MEETING:	PLANNING AND REGULATORY COMMITTEE
DATE:	19 NOVEMBER 2025
TITLE OF REPORT:	<p>222138 - OUTLINE PLANNING APPLICATION WITH ALL MATTERS RESERVED, EXCEPT ACCESS, FOR THE FIRST PHASE OF AN URBAN EXTENSION COMPRISING UP TO 350 HOMES (USE CLASS C3); AND A CARE HOME (USE CLASS C2), PARK & CHOOSE INTERCHANGE; TOGETHER WITH OPEN AND PLAY SPACE, LANDSCAPING, INFRASTRUCTURE AND ASSOCIATED WORKS. AT LAND AT THREE ELMS, NORTH EAST QUARTER, TO THE NORTH EAST OF HUNTINGTON AND BOUNDED, BY THREE ELMS ROAD AND ROMAN ROAD, HEREFORD, HR4 7RA</p> <p>For: The Church Commissioners for England per Miss Tara Johnston, The Minster Building, 21 Mincing Lane, London, EC3R 7AG</p>
WEBSITE LINK:	<u>Planning Application Details - Herefordshire Council</u>
Reason Application submitted to Committee - Redirection and need for strategic overview.

Date Received: 29 June 2022
Expiry Date: 30 November 2025

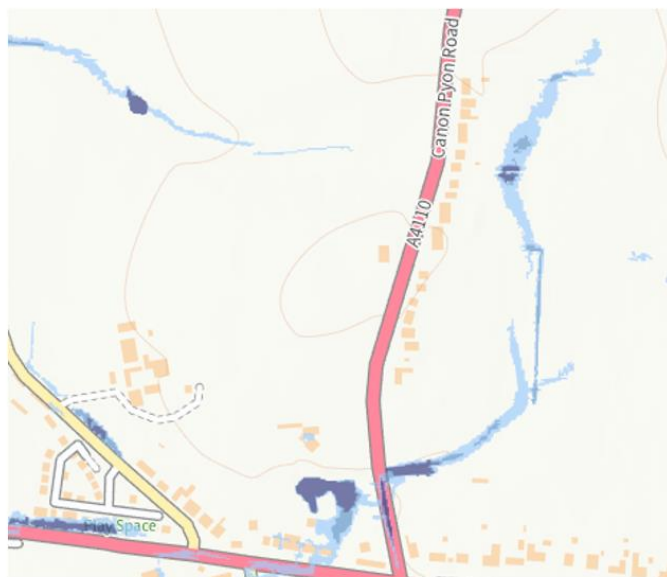
The Livestock Market was constructed around 15 years ago when SuDS guidance was less developed. The applicant has queried whether the SuDS were installed correctly. Whilst the site is quite large, it is not on the banks of the Yazor Brook, moreover there are other impermeable areas upstream such as the Credenhill MOD base. We request that the applicant advises how impermeable areas within the catchment were modelled and provides commentary and technical justification for the runoff that may occur from these sources. As there is an absence of design information, runoff **rates** and **volumes** from the Livestock Market may be assumed to be increased.

7.11.2023 The applicant has provided commentary (23.10.2023) as follows. It is recognised that modelling techniques rely on the adoption of parameters that are selected to define the catchment using a coarse approach, which makes simulation of fine detail impractical (e.g. localised impermeable areas).

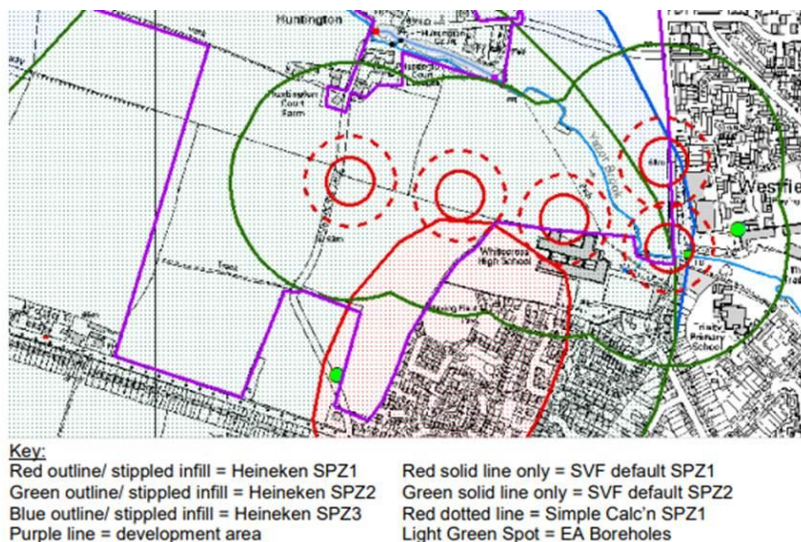
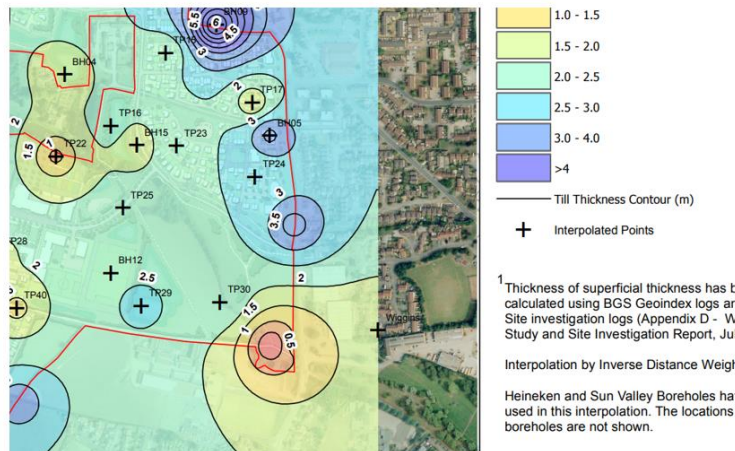
There is a risk that the A4110 (Three Ellms Road) culvert could become subjected to a partial blockage. An assessment is required to demonstrate the impact of a 50% blockage in the event of a 100 year + 37% climate change storm.

The FRA supporting application 162690 addendum included hydraulic modelling of the Yazor Brook to assess the benefits of on-site fluvial storage and to ensure that the works (and scheme as a whole) do not increase flood risk outside of the site boundary. Under more recent dialogue with the EA the concept of lowering ground levels in SPZ1 has been rejected.

7.11.2023 The 50% blockage scenario could be addressed at Reserved Matters stage.

13.8.2023 The applicant has presented proposals for ground lowering within R04 that would mobilise a maximum of 1500m³ flood storage. Figure 7.2 in the modelling report shows that this would be installed on the eastern side of the Yazor Brook. The SPZ extents could however alter on receipt of the forthcoming groundwater modelled SPZ extents. This may make it possible to increase the size of the flood storage area. The modelling results do not show a tangible benefit and so re-sizing of the storage area would be encouraged after the SPZ extents are known

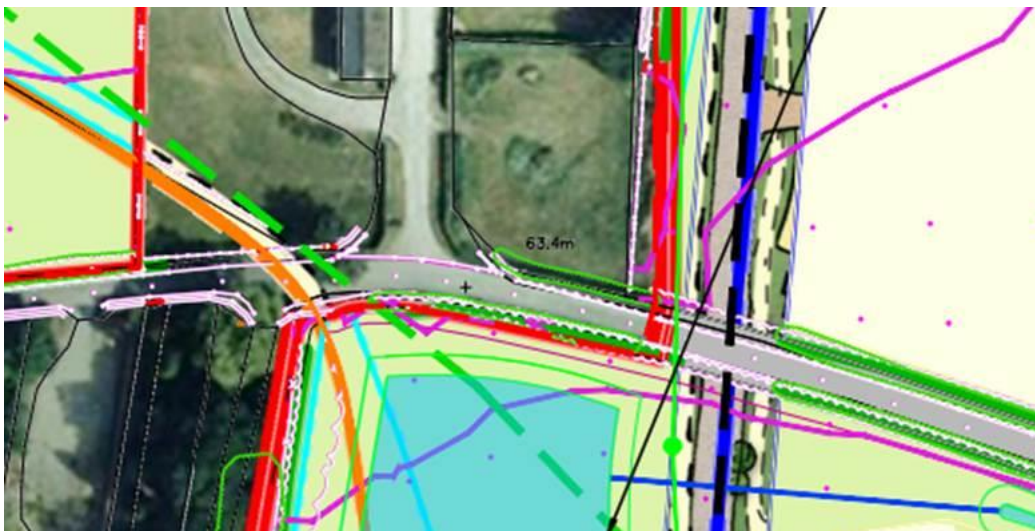
The revised drawing shows a short highway culvert installed between the proposed swale and the ditch. The applicant will need to consider the depth of any ditch and the size of this culvert, noting the requirements of the Culvert Design Guide. The 100 year + Climate change design flow needs to be established to confirm flow capacity requirements are met. Security screens present a risk of blockage and so should be designed out. If a short section of culvert is proposed, then it may be possible to avoid installing security screens at both the inlet and outlet, by following the respective design guidance. Through careful design it may be possible to eliminate the need for such screens. Twin culverts are not preferred as one culvert will tend to block. Further clarity on these proposals is needed.

Balancing Pond B2 appears to be proposed over the top of an abandoned DCWW water main. Permission would be required from DCWW regarding removal of this apparatus. The size of the easement alongside the strategic DCWW water main west of Balancing Pond B2 should be shown on the layout plan.

7.11.2023. The water main is labelled as abandoned, but still remains a DCWW asset. Abandoned water mains remain valuable assets. In some cases, it is viable to return abandoned water mains into service. The water companies sometimes use the abandoned mains as sheaths (inserting new foul or clean water pressure mains inside them) thus avoiding the need to excavate when they install new assets. The water companies would have the rights to allow other utility companies to utilise the redundant mains.
